Staff Report

To: Salt Lake City Planning Commission
From: Chris Lee, 801-535-7706
Date: November 8, 2018
Re: PLNSUB2018-00496 and PLNSUB2018-00668 – Guadalupe Row Houses

Planned Development and Preliminary Subdivision

2 DEMO SITE PLAN
1" = 20'-0"

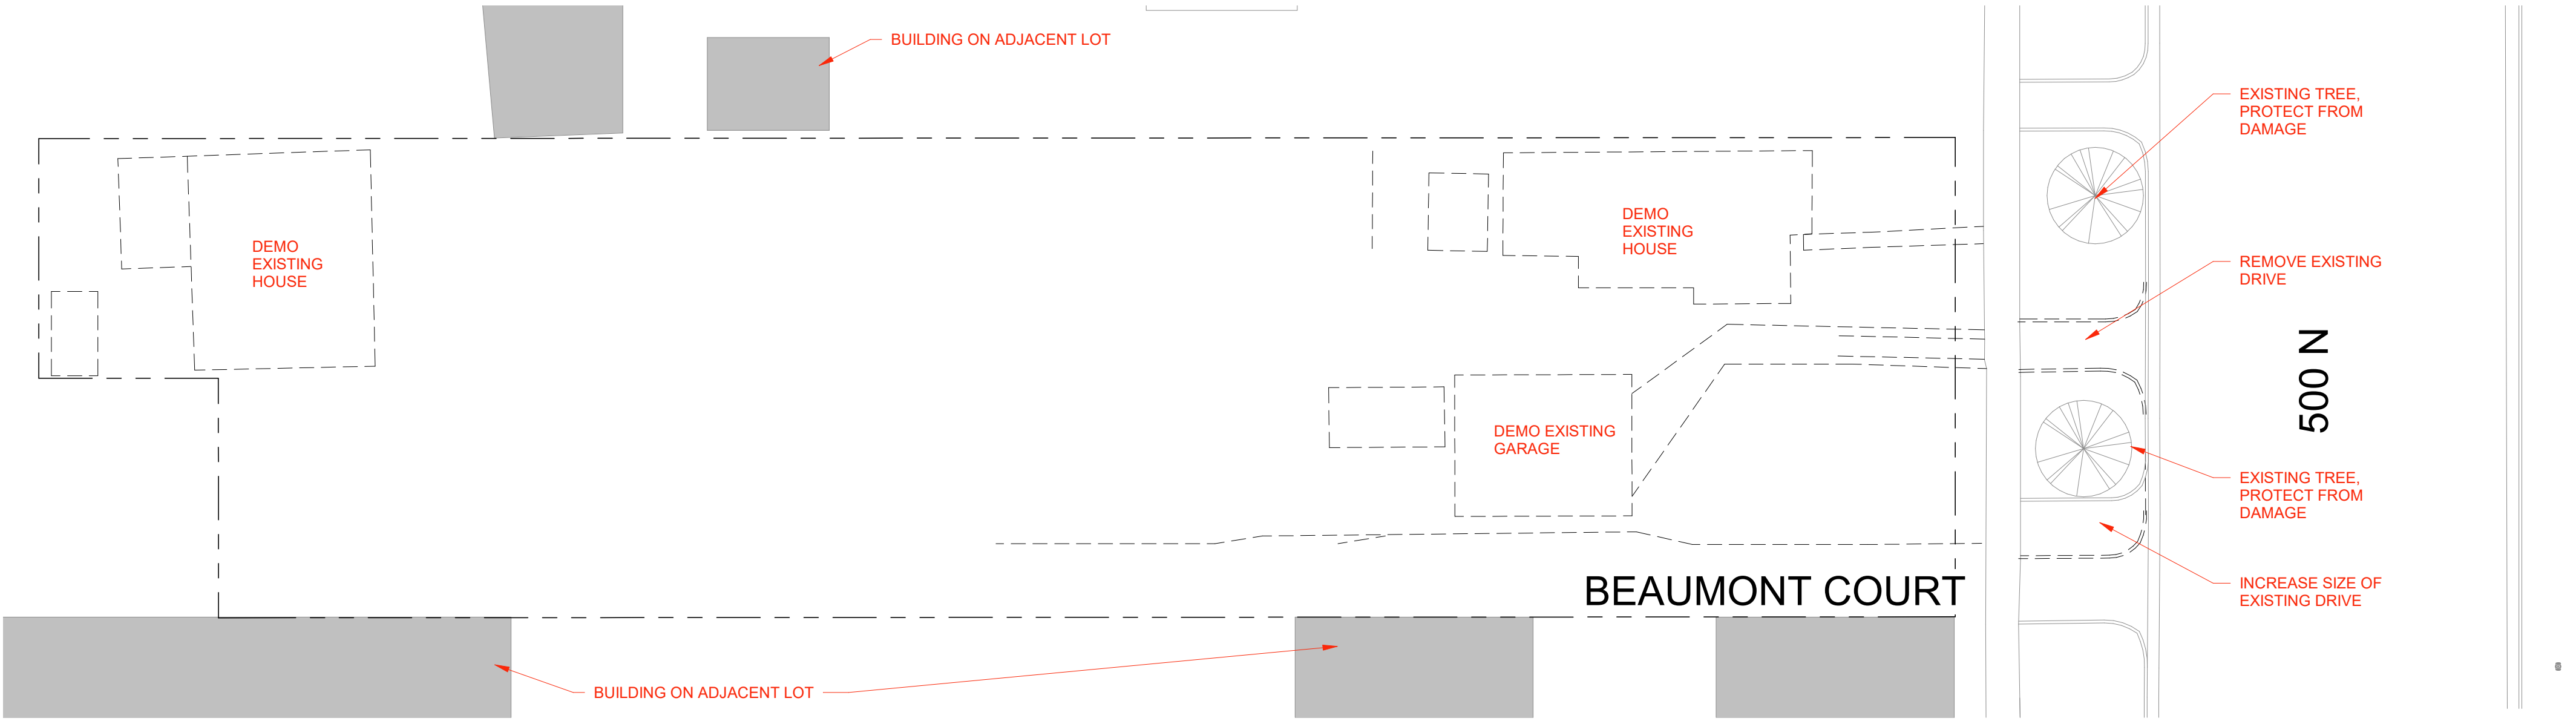
Any park strip tree removal/protection/planting will need to be evaluated by Urban Forestry. The Demo Site Plan does not indicate the location of existing park strip trees and whether they are to be removed or retained.
